ULNRC- 04558

**DOCKET NUMBER 50-483
CALLAWAY PLANT
UNION ELECTRIC COMPANY
RESPONSE TO REQUEST FOR ADDITIONAL INFORMATION
ON REVISION TO TECHNICAL SPECIFICATION 5.5.9
"STEAM GENERATOR (SG) TUBE SURVEILLANCE PROGRAM"**

**REQUEST FOR ADDITIONAL INFORMATION
REVIEW OF THE CALLAWAY PLANT APPLICATION
FOR REVISION TO TECHNICAL SPECIFICATION 3/4.4
TAC NUMBER: MB1214**

Figure R30-7

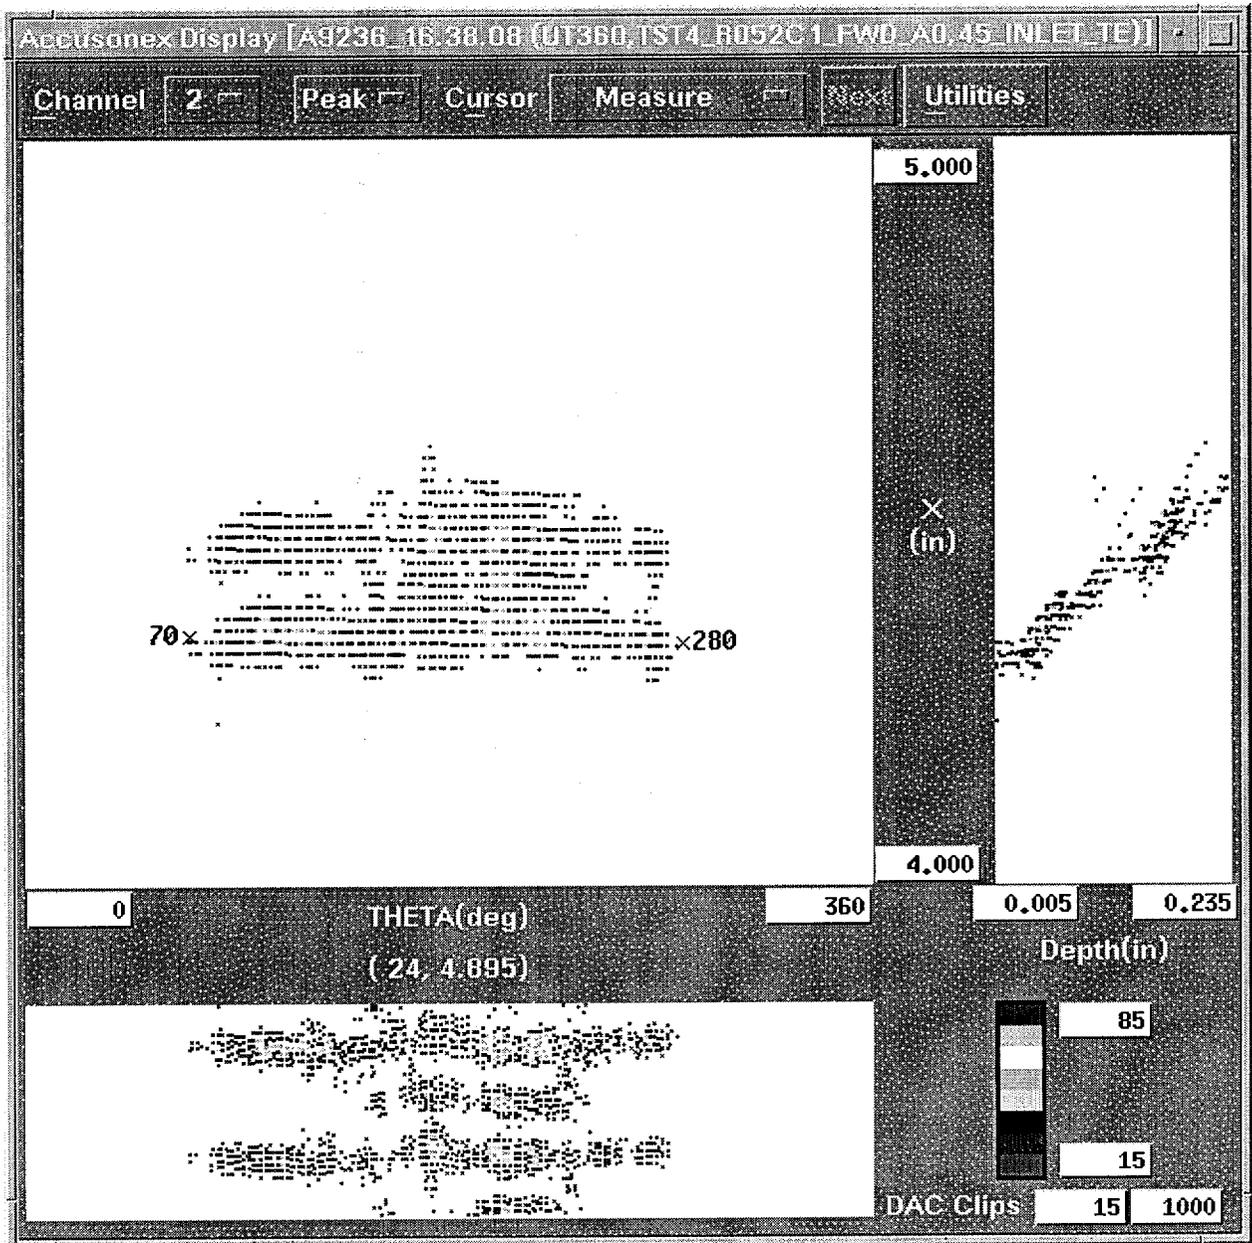
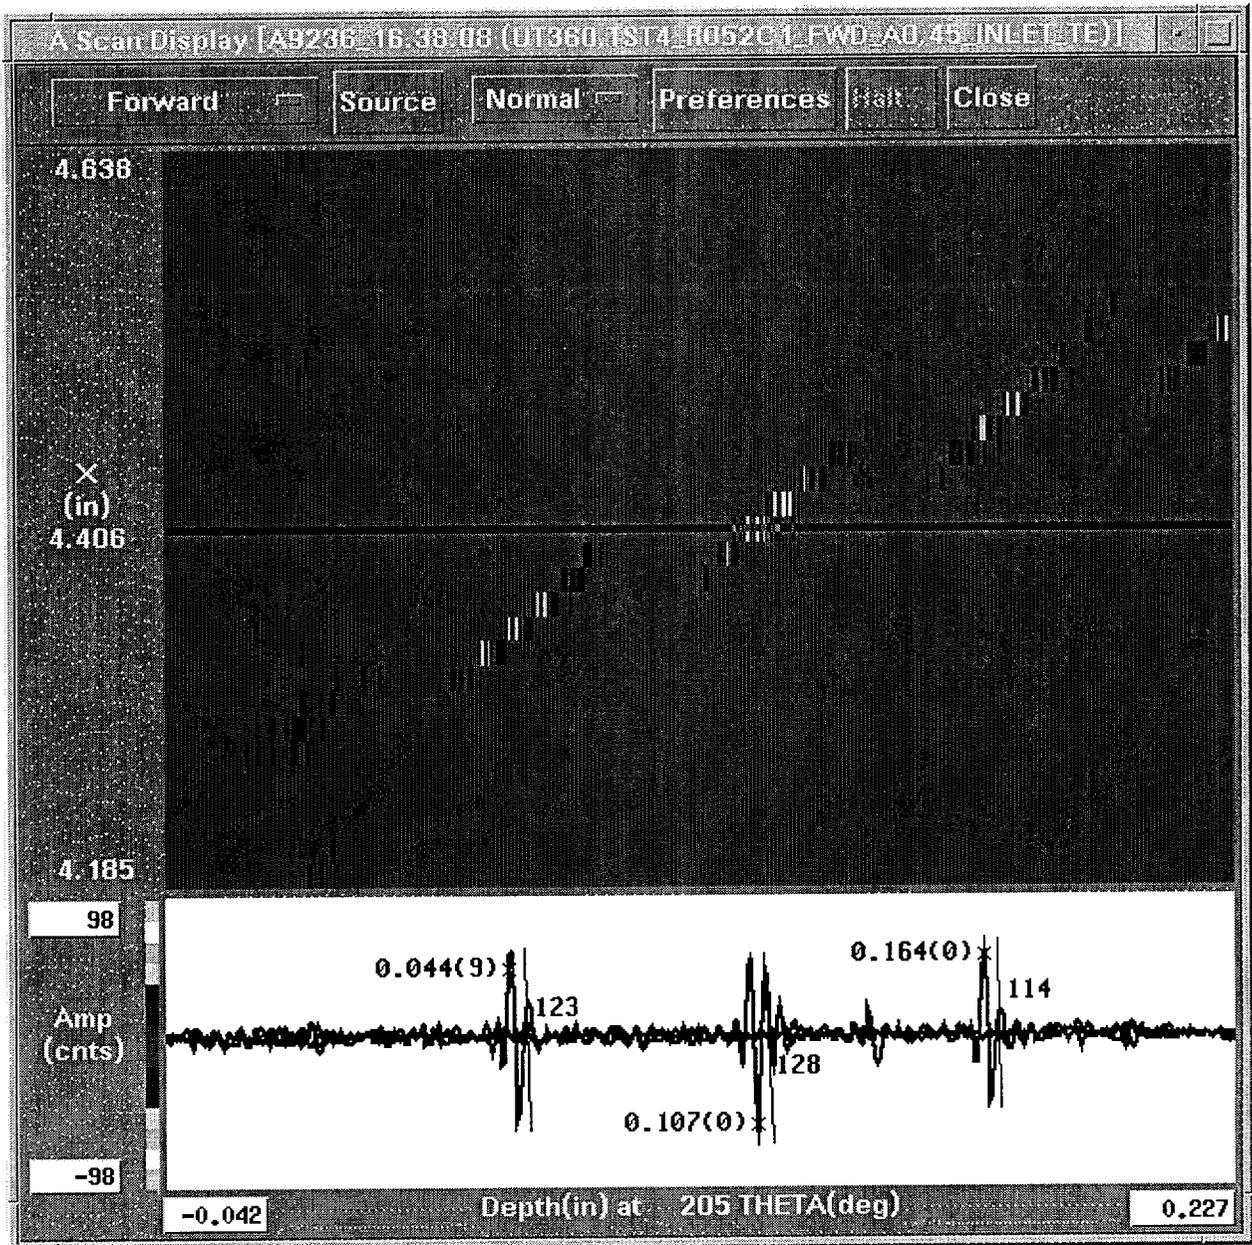
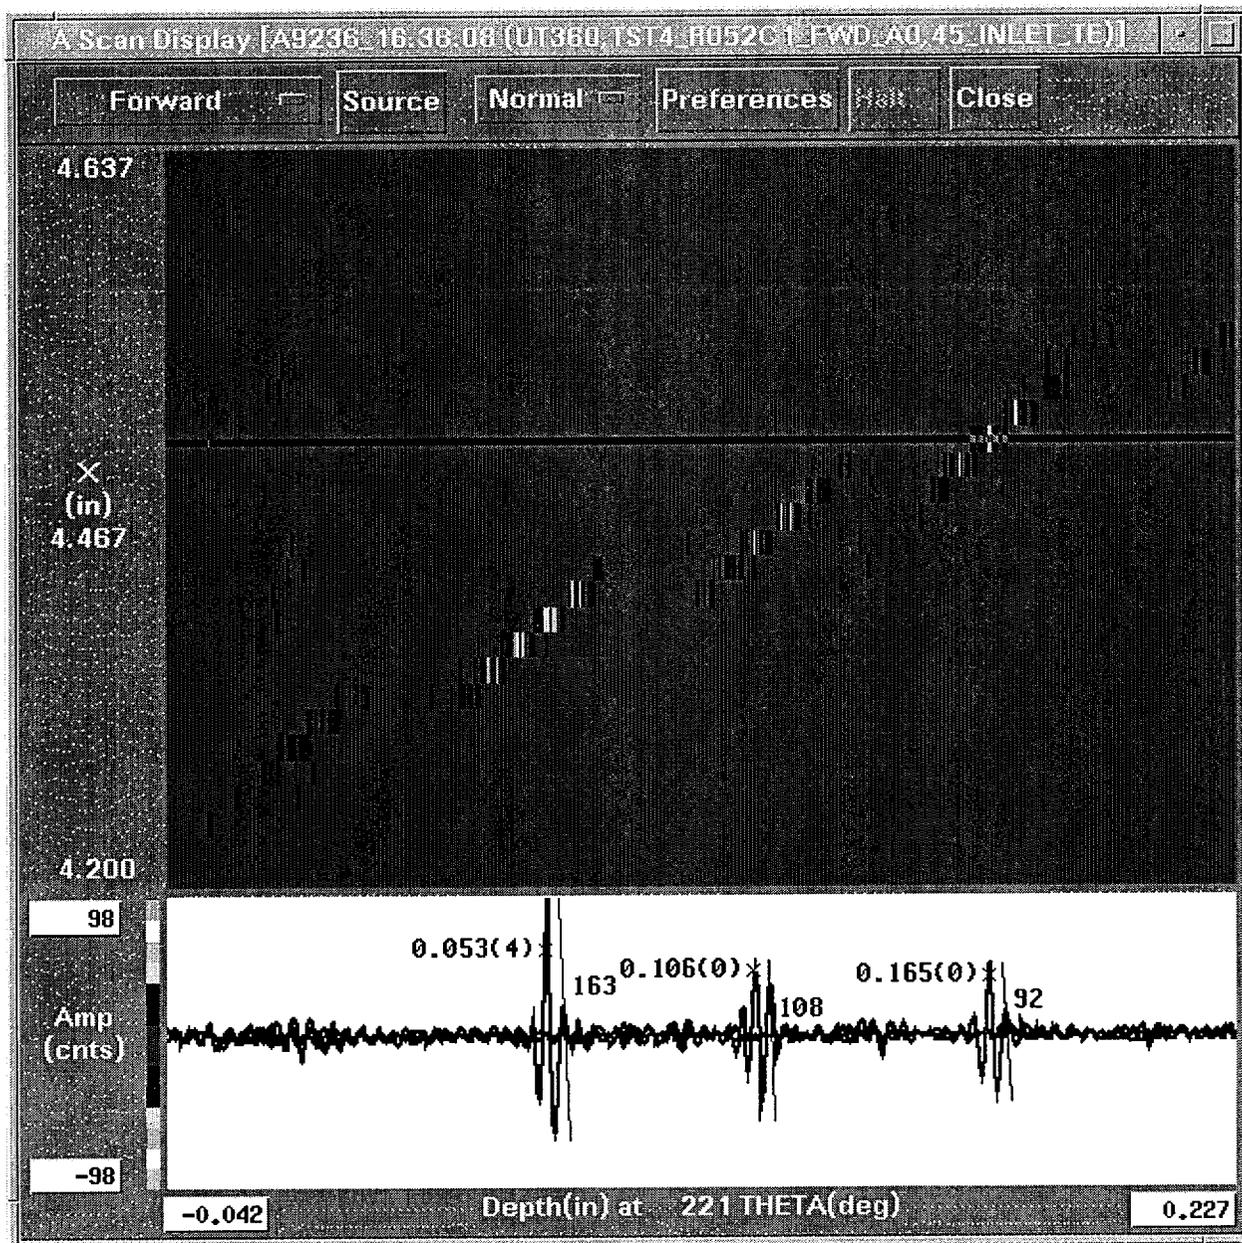
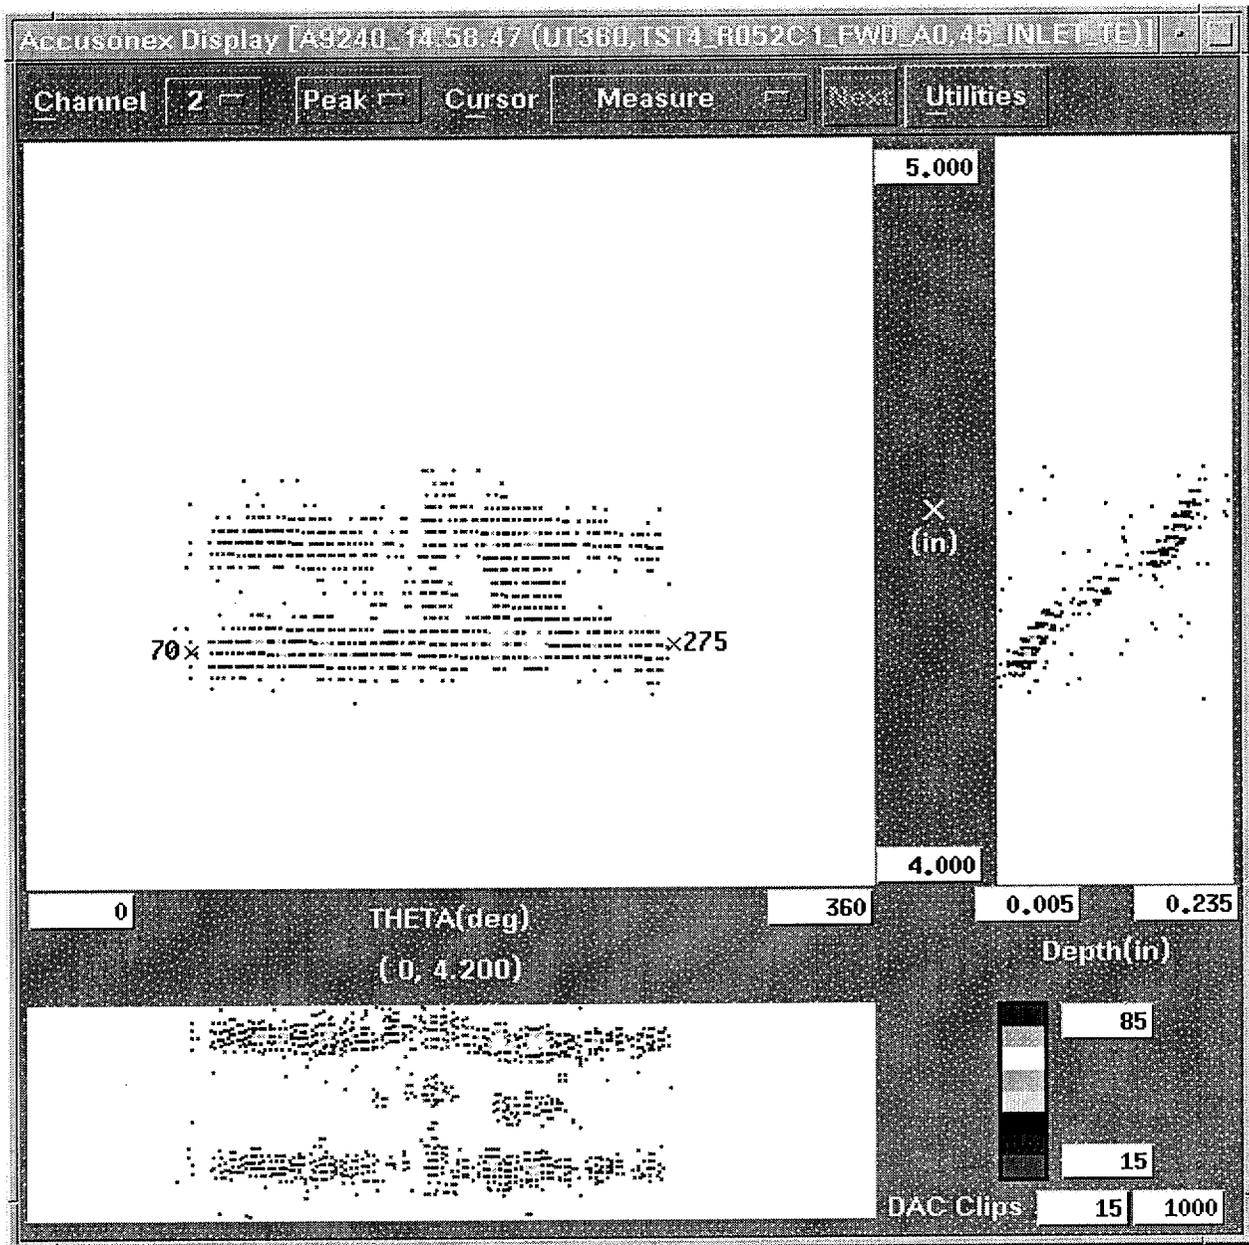
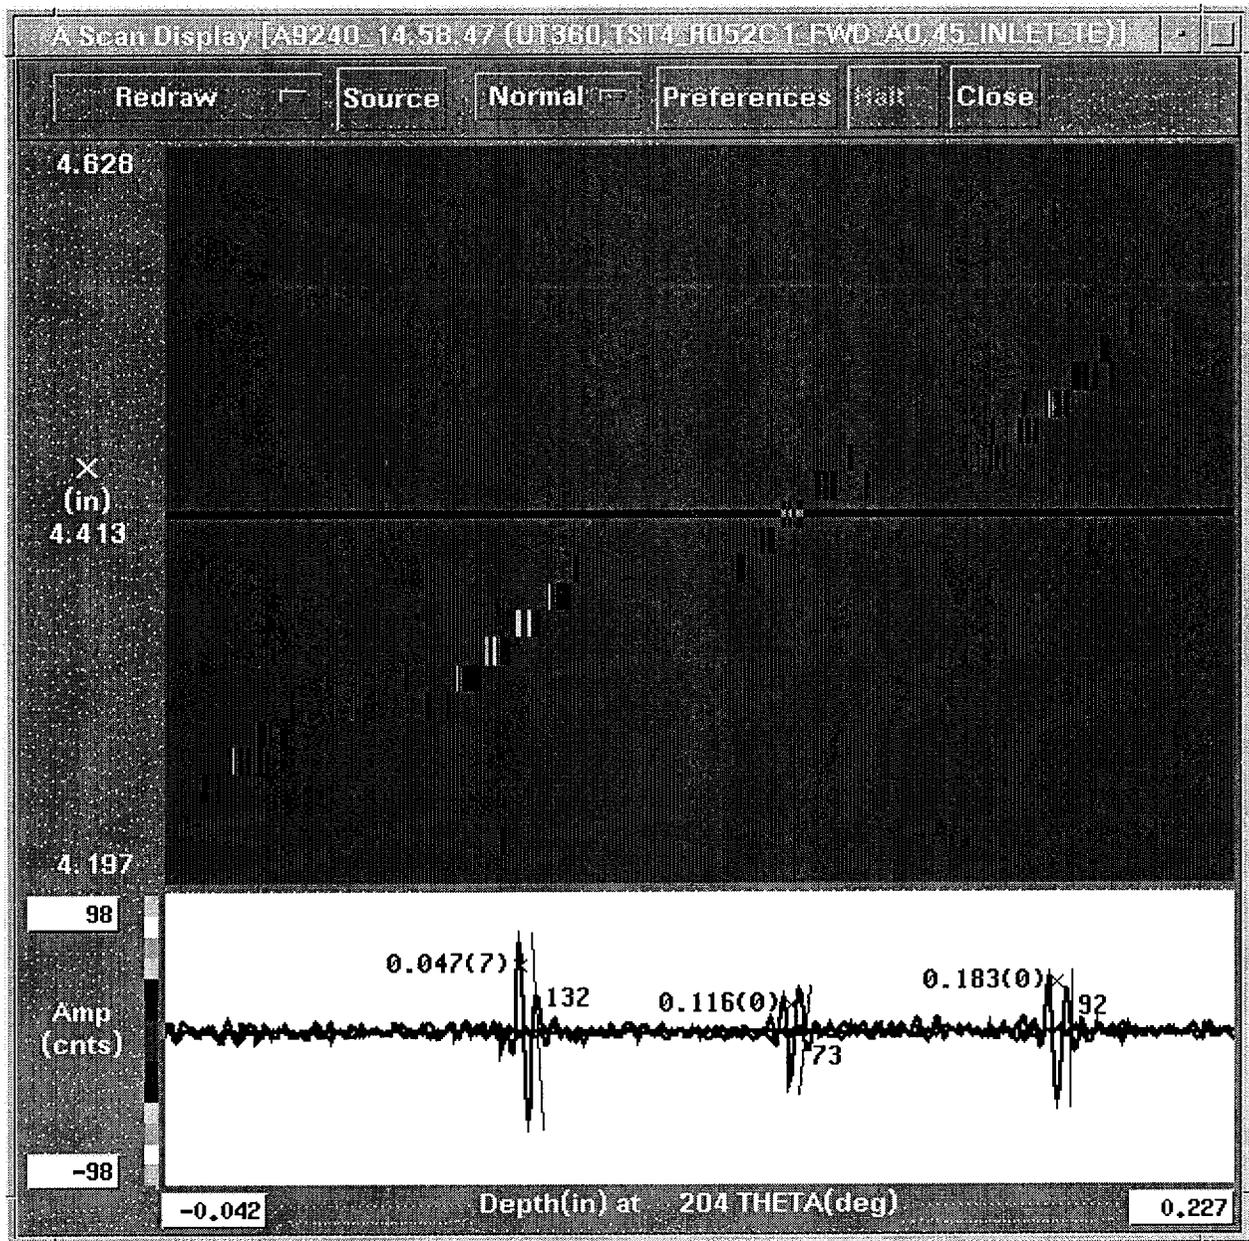
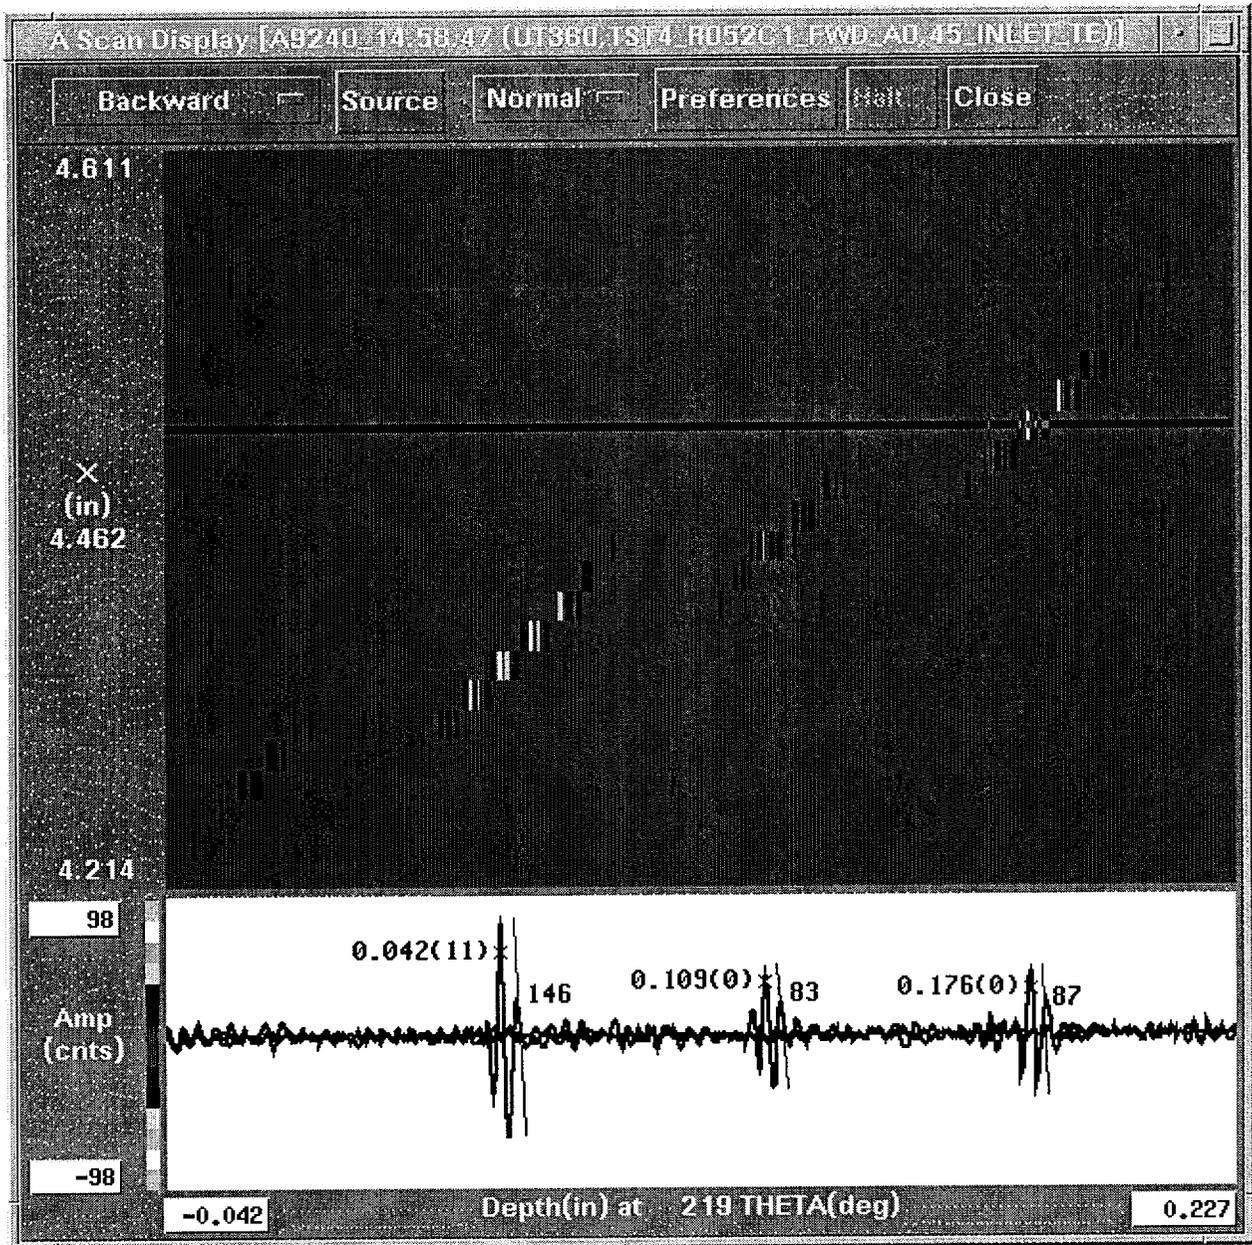
RAI # 30. The report states that “UT techniques have been shown to be effective in the detection and sizing of fatigue cracks propagated into the sleeve material.” Please provide data to support this assertion. (Page 11-57, BAW-10219P, Rev. 4)

This is the pre-fatigue crack C-Scan plot of the ODSCC circumferential crack in tube TST4-072-1. The crack extent (length) can be estimated from the C-Scan plot as $(278 - 85)$ or 193 degrees. The plot shows the presence of a half skip response, a one and one half skip response and some full skip reflections.

This is the post-fatigue crack C-Scan plot of the ODSCC circumferential crack in tube TST4-072-1. The crack extent (length) can be estimated from the C-Scan plot as $(275 - 80)$ or 195 degrees. The fatigue cycling has not significantly increased the crack extent (length). The plot shows the presence of a half skip response, a one and one half skip response and an increase in the full skip response.

This is the pre-fatigue crack C-Scan plot of the ODSCC circumferential crack in tube TST4-052-1. The crack extent (length) can be estimated from the C-Scan plot as $(280 - 70)$ or 210 degrees. The plot shows the presence of a half skip response, a one and one half skip response and some full skip reflections between the 148 degree and 234 degree locations along the crack extent.

This is the post fatigue crack C-Scan plot of the ODSCC circumferential crack in tube TST4-052-1. The crack extent (length) can be estimated from the C-Scan plot as $(280 - 70)$ or 210 degrees. The plot shows the presence of a half skip response, a one and one half skip response and an increase in the full skip response between the 200 degree and 230 degree locations along the crack extent.

This is the post final deposition C-Scan plot of the ODSCC circumferential crack in tube TST4-052-1. The crack extent (length) can be estimated from the C-Scan plot as $(275 - 70)$ or 205 degrees. The plot shows the presence of a half skip response, a one and one half skip response and the diminished amplitude of the full skip response.
